MAX CRUISE MOD BLOCK DEFINITION

PROGRESS REPORT

Date: 12 March 1976

Issue 2 21st April 1976

FIG 1-2-1 F.D. GAIN SWITCHING (DCR 10099)

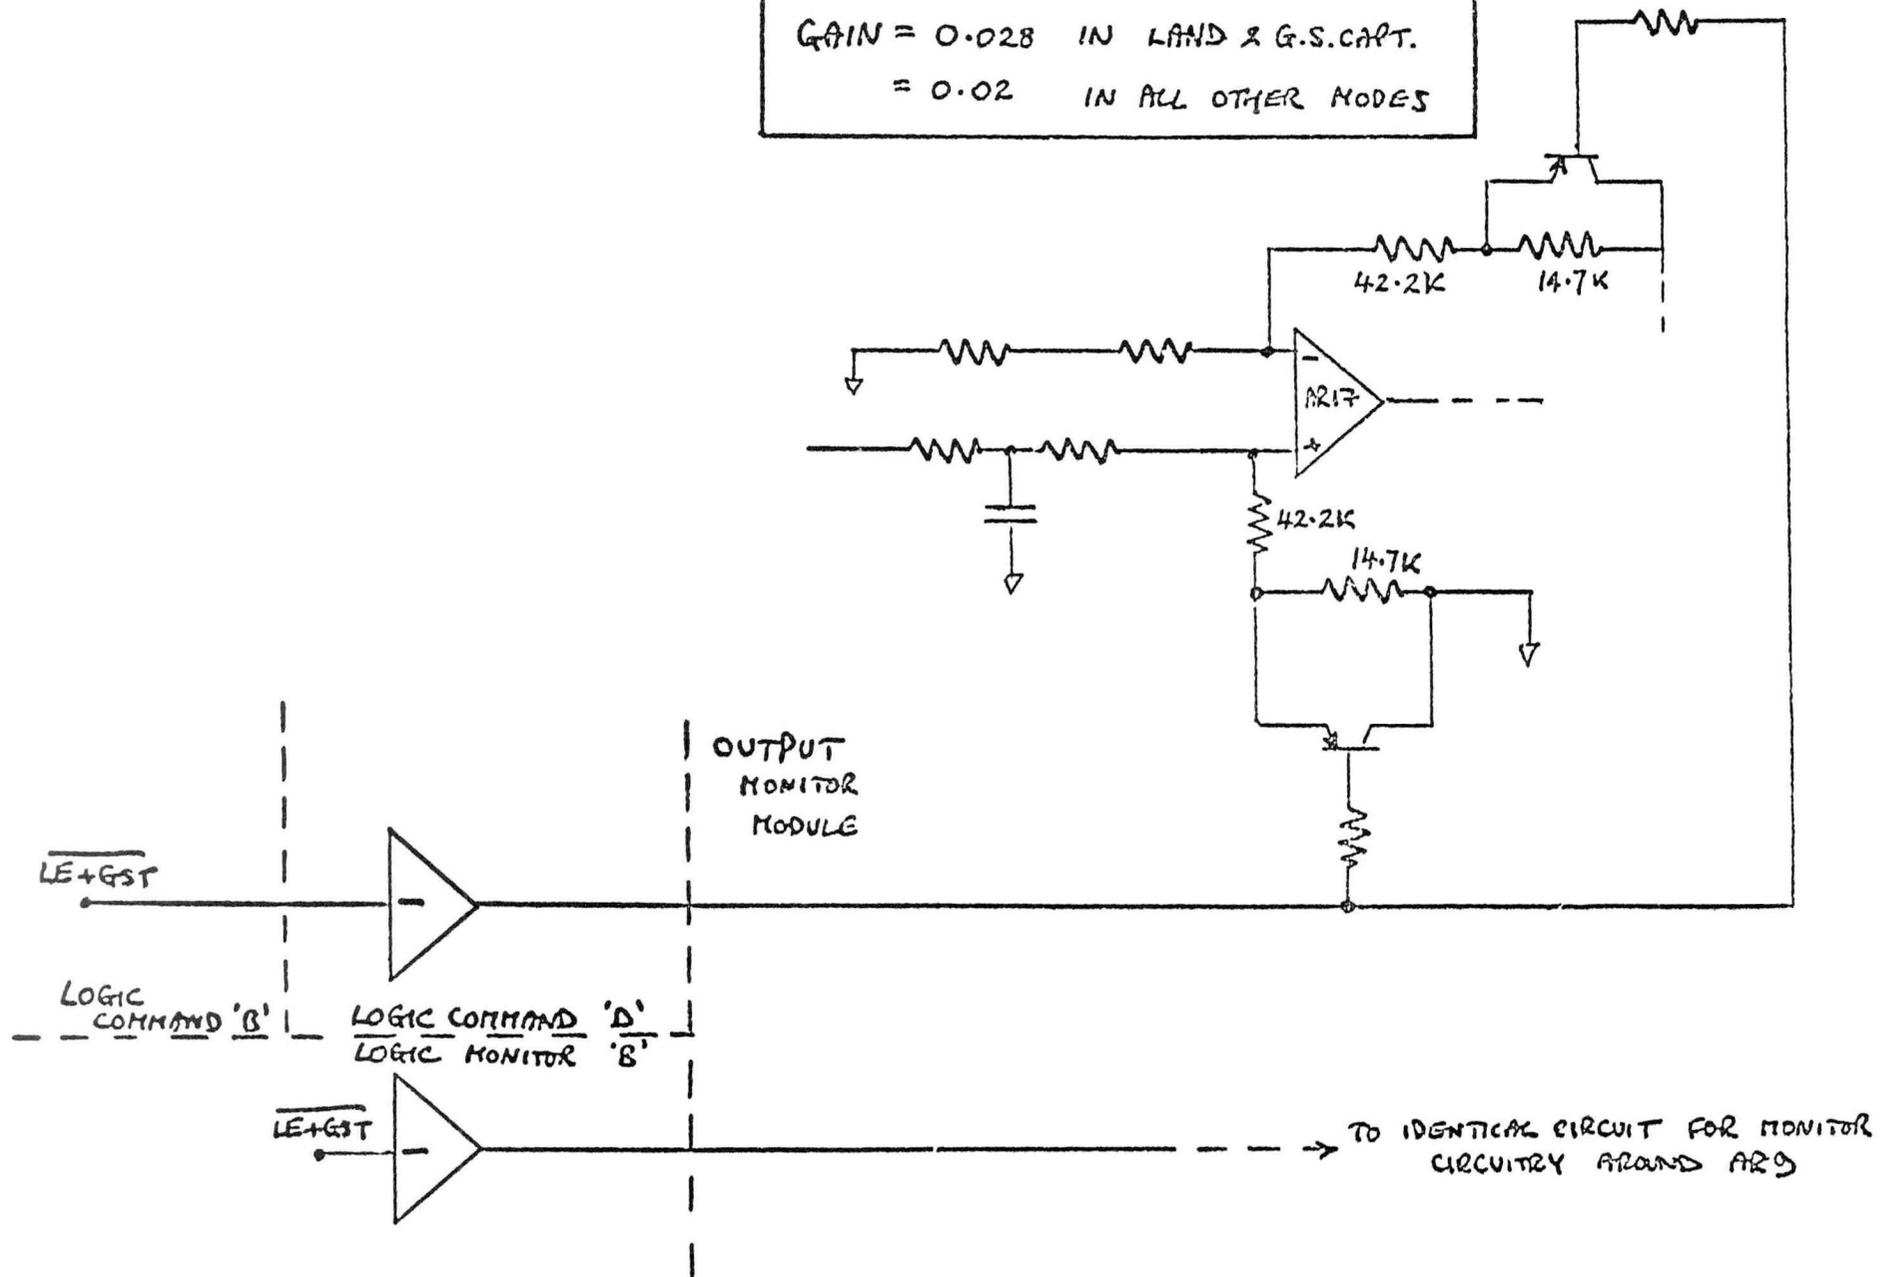
- 1.2. DCR 10099 (Increase of FD gain by 40% in LAND and Glide Slope capture  
Two new logic drives (LE + GST), S59, switch the Flight Director gains on the Output Monitor module. Fig. 1.2.1 refers.

A-FIG.1-3-1 ALTITUDE ALERT FALSE WARNINGS

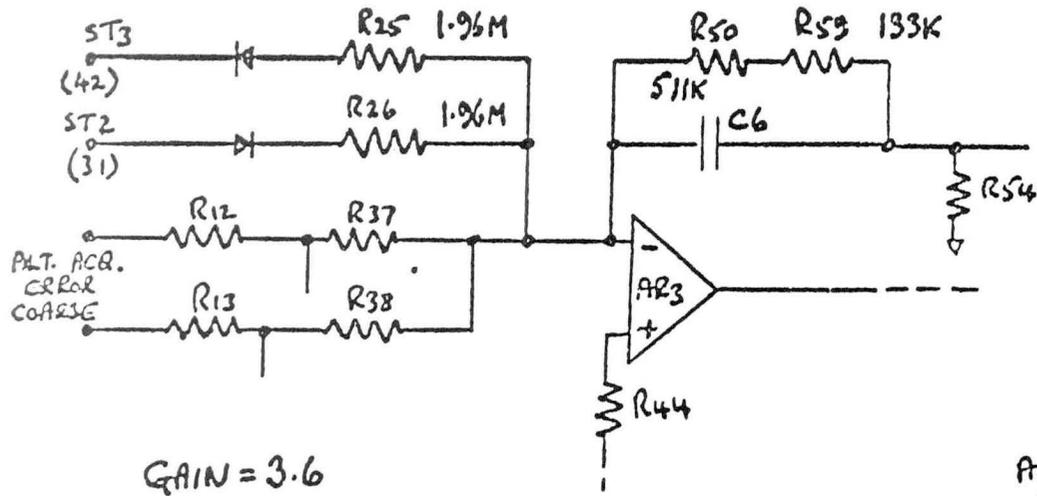
The analogue level switch (outer boundary) supplies two logic gates and because of the difference in thresholds of these gates a logic 'race' was occurring which occasionally resulted in Alt. Alert warnings on the approach. This has been overcome by the addition of logic gate buffers. A smoothing capacitor has also been added to reduce noise from the logic power supply on the Alt. Alert module. Fig. 1.3.1 refers.

ADD A 0.1 $\mu$ F CAPACITOR BETWEEN Q7 (BASE) AND LOGIC EARTH

A FIG 1-3-2 ALTITUDE ACQUIRE SCALING

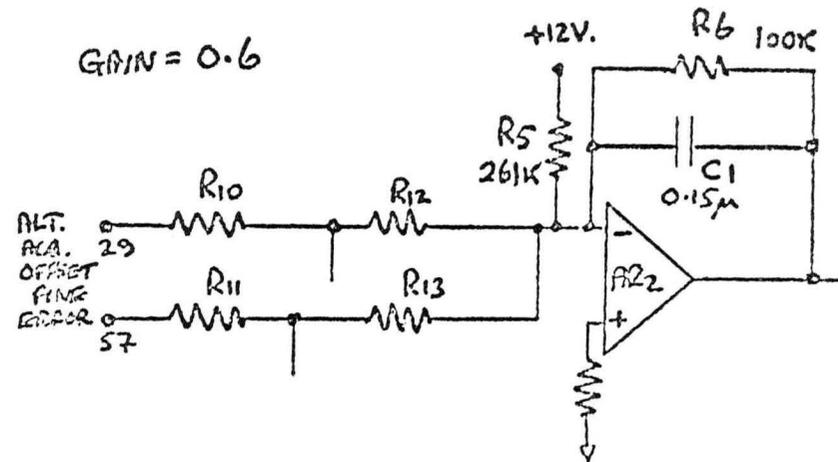
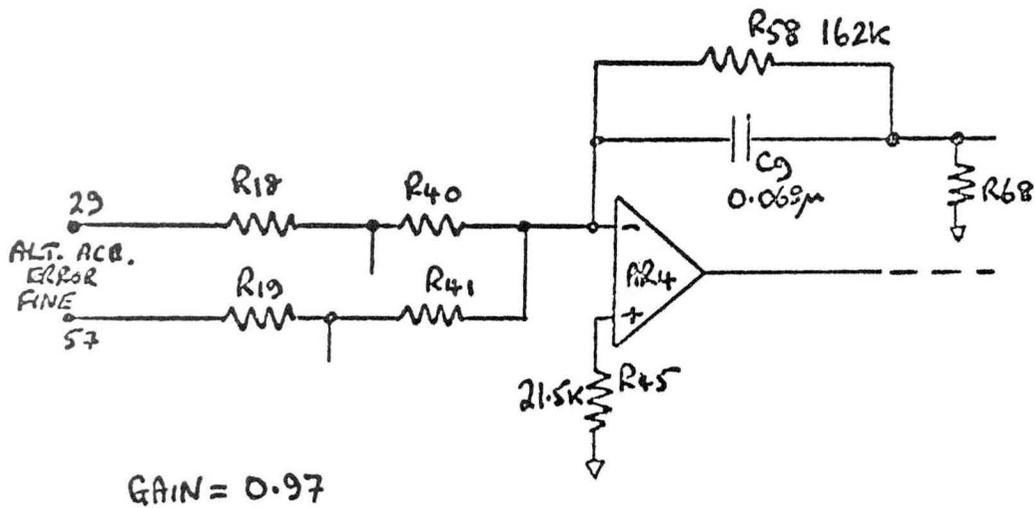
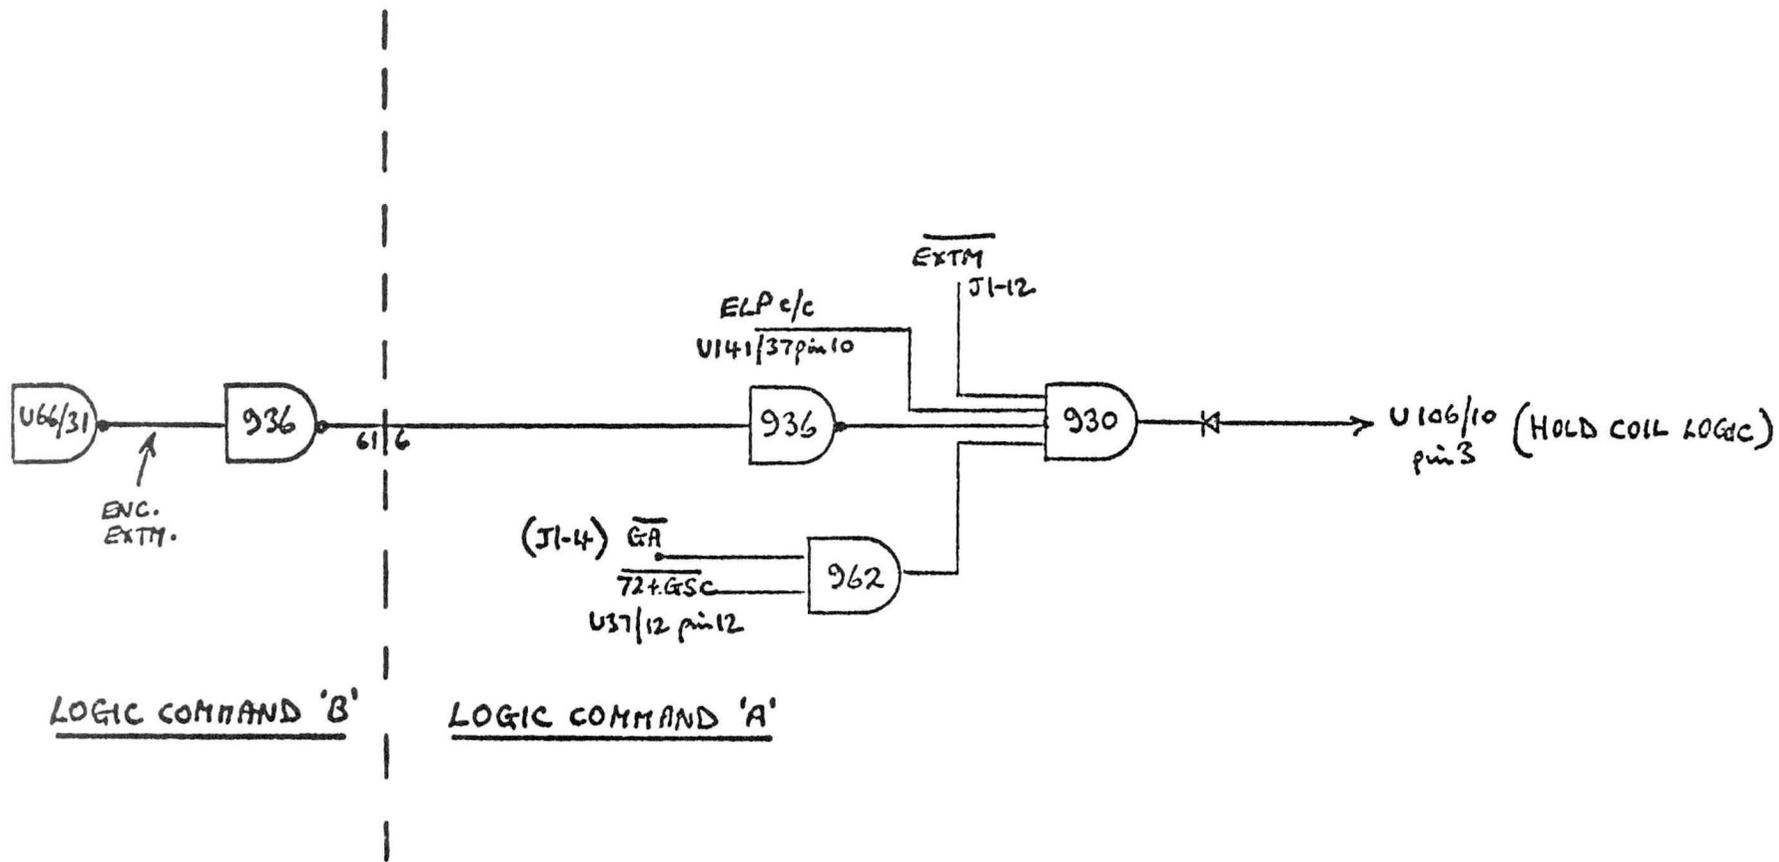
The incompatible synchros used in the Altimeter (which supplies the Pilots Control Unit for Flight level reference) result in a low sensitivity at the Pitch computer interface. To correct for this the gains in the APFD (Pitch) computer have been changed in the Alt. Acq. coarse and fine and offset fine chains. The scaling to be accommodated is  $265 \text{ mV}/^\circ$  in the coarse computing and  $213 \text{ mV}/^\circ$  in the fine and offset fine computing. The chopping phase reference has also been altered to  $65^\circ$  to correct for the large phase shifts introduced by this mis-matched synchros.

SNIA note 462.277/76 and telex no. 12 of 26.2.76 recommend that the gains in the fine and offset fine computing only are altered (together with a phase shift of  $65^\circ$ ) and that the coarse sensitivity be corrected by changing the threshold of the 2500' level switch fed from the coarse error information.

This has not been done, as explained above, since the Alt. Acquire coarse input is used to compute the APFD demand in the Alt. Acquire mode and performance would remain poor if this were not corrected.

PHASE-SHIFT GENERATOR - AR10
C21 CHANGED TO 0.015uF

A - FIG. 1-4-1 LOSS OF EXTERNAL MODE LOGIC

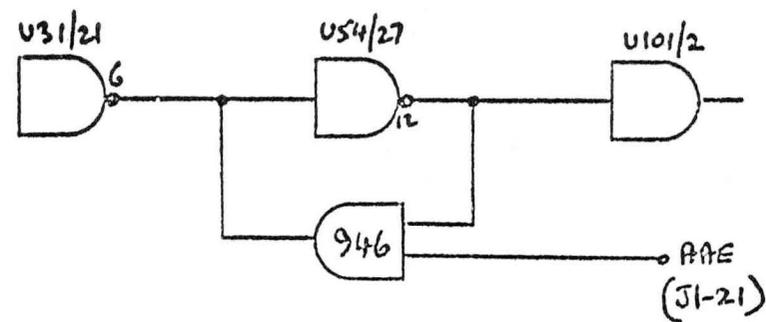
It had been noted in SNIA note 452.119/75 Issue 2 that a loss of the encoded External mode information (EXTM.) during LAND would cause loss of Flare which may go unnoticed by the crew and result in a hard and short landing. Various schemes to overcome this have been tried and tested on the SNIA logic simulation. The final, agreed (ref. SNIA telex no. 14 of 9.3.76 and MEA telex no. 6556 of 22.3.76) solution operates directly on the Autopilot hold coil logic such that if EXTM is not present (due to a failure) when in LAND mode and Land Engage has occurred then a disconnect results and an autochangeover into the other, healthy, Autopilot will occur. The input of EXTM encoded is necessary to ensure transient free operation until the appearance of EXTM after Glide Slope capture. Fig. 1.4.1 refers.

A-FIG. 1-5-1 ALT. ACQUIRE SIGN SENSOR LATCH

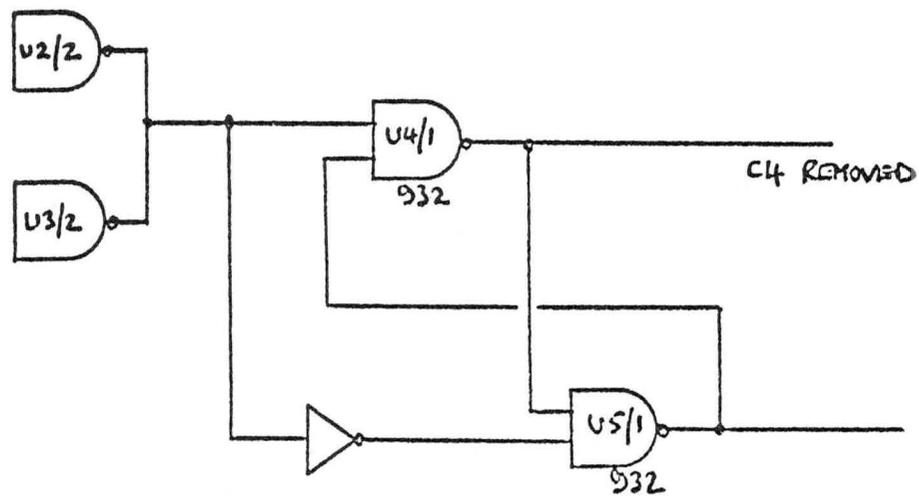
This has proved to be necessary since after Alt. Acquire capture has occurred it is possible (especially when flying close to the flight level to be captured) that the sign sensors used to signal Alt. Acquire capture conditions change state and the mode is lost leading to acquisition of an incorrect flight level.

A - FIG. 2-1 AUTOTHROTTLE MAX. CRUISE ANALOGUE COMPUTING

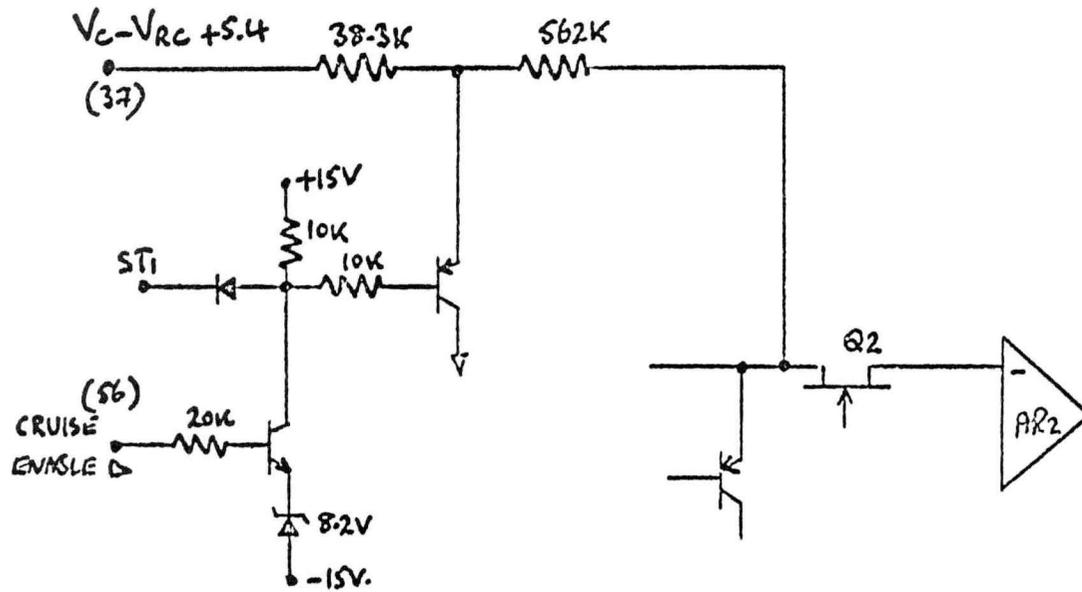
Fig. 2-i illustrates the new analogue input used to connect the Vc - VRC +5.4 kts signal into the outer-loop computing. It will be noted that this input is enabled by the signal 'CRUISE enabled'.
